**ADDENDUM NO. 01
TO THE
BIDDING REQUIREMENTS AND CONTRACT DOCUMENTS
FOR THE
NEW ALBANY UPHILL RUN LIFT STATION PROJECT**

OWNER: City of New Albany
142 East Main Street
New Albany, IN 47150

ISSUED BY/ENGINEER: Beam, Longest and Neff, L.L.C.
8320 Craig Street
Indianapolis, Indiana 46250

ISSUE DATE: November 5, 2021

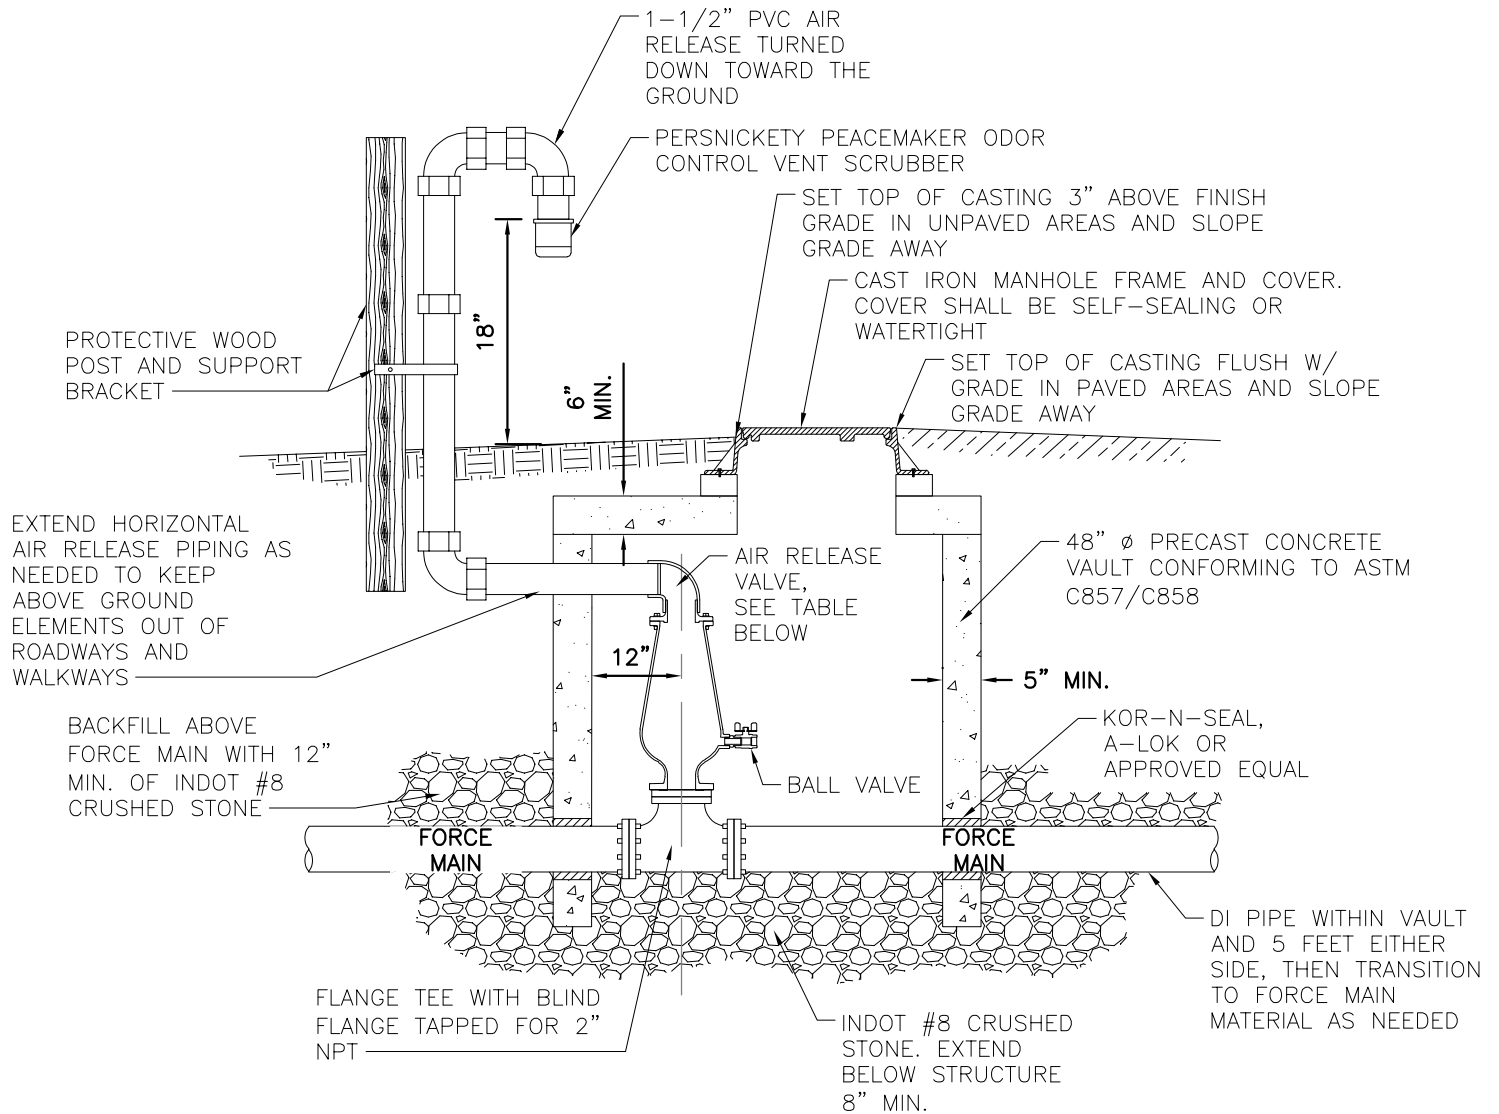
12. Q: Is there a detail for the HMA driveway at lift station (asphalt and stone thickness, asphalt and stone types)?
R: Please see attached "Bituminous Pavement Repair" detail. As shown, commercial driveways shall be 1.5 inches of HMA surface on 3 inches of HMA intermediate on either 6 inches of HMA base or 8 inches of compacted No. 53s.

TYPE	BASE		INTERMEDIATE COURSE	SURFACE COURSE
	COMPACTED AGGREGATE	HMA		
SIDEWALK	4"	OR 3"	1½"	1½"
RESIDENTIAL DRIVE	6"	OR 4"	3"	1½"
LIGHT DUTY ROAD*	8"	OR 6"	3"	1½"
INTERMEDIATE DUTY ROAD	8"	OR 6"	4"	2"
HEAVY DUTY ROAD	6"		9"	1"

*ALL ALLEYS, COMMERCIAL DR. & PUBLIC ROADS SHALL BE CONSIDERED LIGHT-DUTY ROADS UNLESS INDICATED OTHERWISE
